# UNITED STATES PATENT AND TRADEMARK OFFICE

10/750,433

<b>Office Action Summary</b>	Application No. 10/750,433	Applicant(s) CLARK ET AL.	
	Examiner Vinh T. Luong	Art Unit 3682

第 2 図

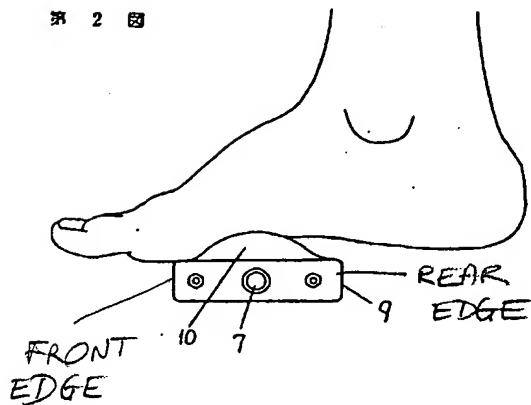
Regarding claim 4, said first surface (Att. 1) further comprises: a front edge *substantially* flush with said rear of said pedal body; and a rear edge *substantially* flush with said front of said pedal body 9, 10 as seen in Fig 2.

第 4 図

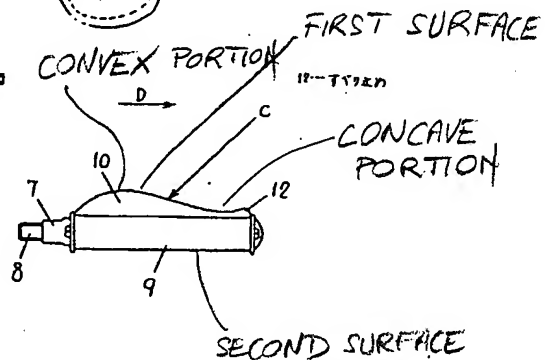
Regarding claim 1, Mitsuo teaches an apparatus 1, comprising: a reversible pedal body 9, 10 having first and second surfaces (at C and 9 in Fig. 4. See Attachment 1), wherein said first surface (C) is adapted to contact an associated foot B, said second surface (9) is adapted to contact an associated shoe, said reversible pedal body being a single part 9, 10, said pedal body 9, 10 having a front (Att. 1) oppositely disposed from a rear (Att. 1), said pedal body having first and second lateral edges (Att. 1) extending between said front and said rear, said pedal body 9, 10 being operatively connected to an associated exercise device 2-6.

Regarding claim 2, said first surface (Att. 1) is curved.

Regarding claim 3, said first surface (Att. 1) further comprises a concave portion (Att. 1) and a convex portion (Att. 1) so as to *substantially* conform to an arch A of the foot B. See English abstract.

FIG. 2

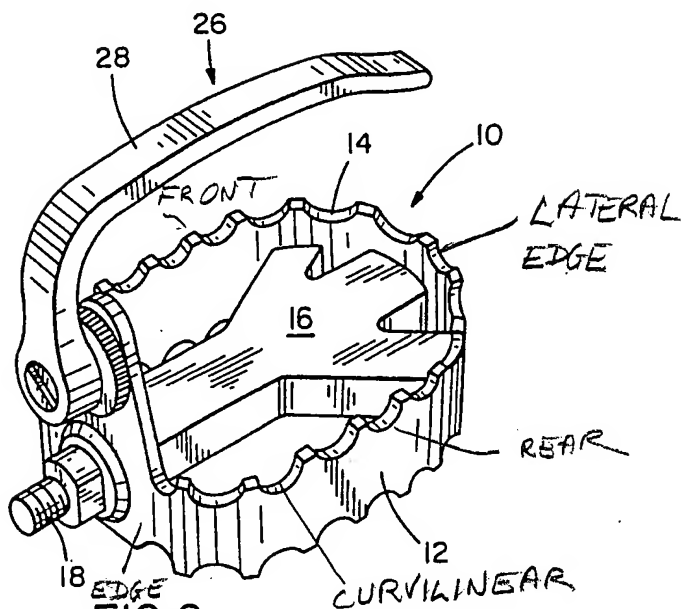
Regarding claim 19, Loppnow's reversible foot pedal further comprises a horizontal plane (passing the axis of rotation of the bolt 18' in Figs. 11 and 12) between said first and second surfaces (Fig. 12 of Att. 2); and at least one weight 16 (Fig. 2) having a central axis (lying on the central, horizontal, bisecting plane of the main pedal portion 12. See Fig. 12 of Att. 2),

FIG. 3

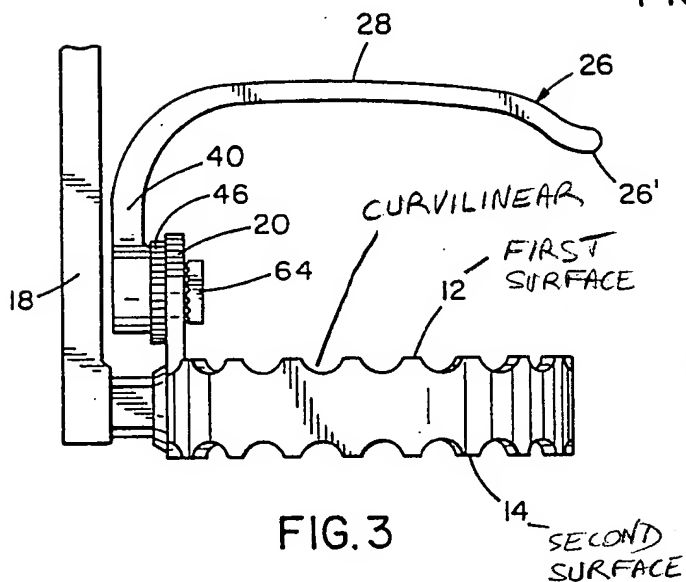
Regarding claim 1, Loppnow teaches an apparatus 10, 10' comprising: a reversible pedal body 12 having first and second surfaces (at 12 and 14 in Fig. 3. See Attachment 2), wherein said first surface (Att. 2) is adapted to contact an associated foot, said second surface (Att. 2) is adapted to contact an associated shoe (Fig. 9 and 10), said reversible pedal body 12 being a single part 12, said pedal body 12 having a front (Att. 2) oppositely disposed from a rear (Att. 2), said pedal body 12 having first and second lateral edges 20 and 20 (Fig. 5) extending between said front (Att. 2) and said rear (Att. 2), said pedal body 12 being operatively connected to an associated exercise device 22.

# **ATTACHMENT 3**

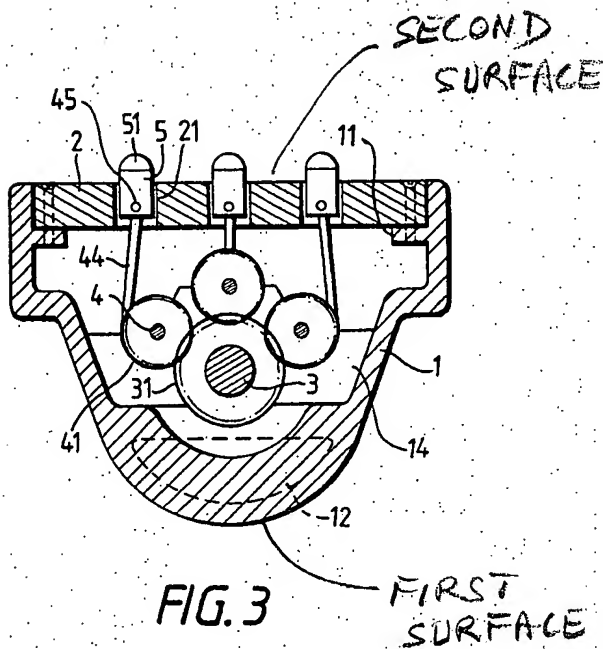
Regarding claim 1, Jean teaches an apparatus comprising: a reversible pedal body 1 having first and second surfaces (at 2 and 1 in Fig. 2. See Attachment 3), wherein said first surface (Att. 3) is adapted to contact an associated foot, said second surface (Att. 3) is adapted to contact an associated shoe, said reversible pedal body 1 being a single part 1, said pedal body 1 having a front (Att. 3) oppositely disposed from a rear (Att. 3), said pedal body 1 having first and second lateral edges (Att. 3) extending between said front (Att. 3) and said rear (Att. 3), said pedal body 1 being operatively connected to an associated exercise device. *Ibid.* col. 1, lines 6-14, and claims 1-12.

Regarding claim 12, Jean teaches a foot pedal for an exercise device, comprising: a reversible pedal body 1 having first and second surfaces (Att. 3), wherein said first surface (Att. 3) is adapted to contact an associated foot, said first surface (Att. 3) being curvilinear (Figs. 3 and 7, Att. 3), said second surface (Att. 3) is adapted to contact an associated shoe, said pedal body 1 having a front (Att. 3) oppositely disposed from a rear (Att. 3), said pedal body 1 having first and second lateral edges (Att. 3) extending between said front (Att. 3) and said rear (Att. 3), said pedal body 1 being operatively connected to an associated exercise device.

FIG. 3

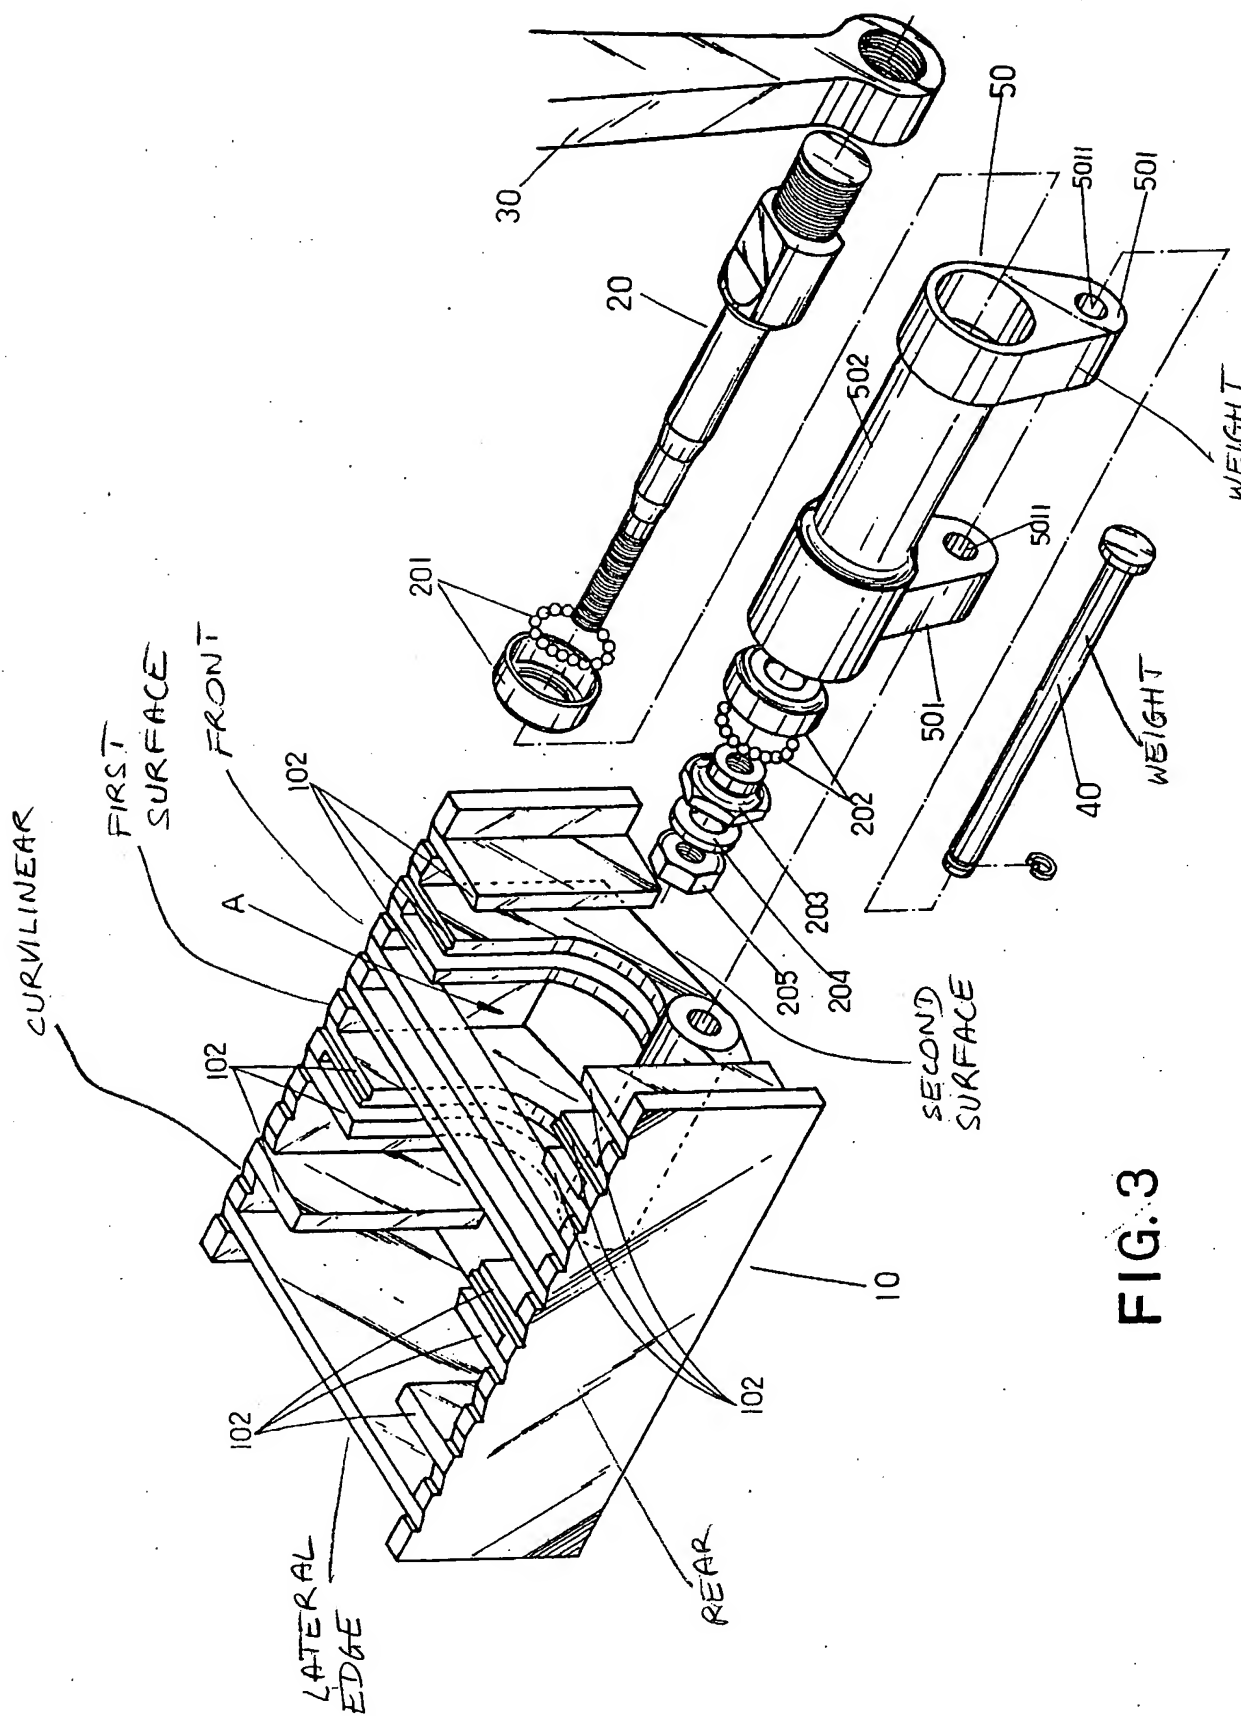
Regarding claim 12, Fan teaches a foot pedal for an exercise device, comprising: a reversible pedal body 10 having first and second surfaces (see Attachment 4), wherein said first surface (at 102 in Fig. 3) is adapted to contact an associated foot, said first surface being curvilinear (at the serrations as seen in Fig. 3, Att. 4), said second surface (Att. 4) is adapted to contact an associated shoe, said pedal body 10 having a front (Att. 4) oppositely disposed from a rear (Att. 4), said pedal body 10 having first and second lateral edges (Att. 4) extending between

Regarding claim 15, said foot pedal comprises a plurality of weights 501 and 40 operatively connected to said pedal body 10 such that one of the surfaces faces substantially upwards as it reaches an equilibrium position. Note that each of the elements 501 and 40 inherently has a weight since each of them is inherently subjected to gravitational force exerted by the earth. The weight of each of the elements 501 and 40 urges Fan's pedal in a vertical position as explicitly shown in Figs. 5-9 and described in col. 1, lines 4-64. Therefore, the elements 501 and 40 are a plurality of weights as claimed.
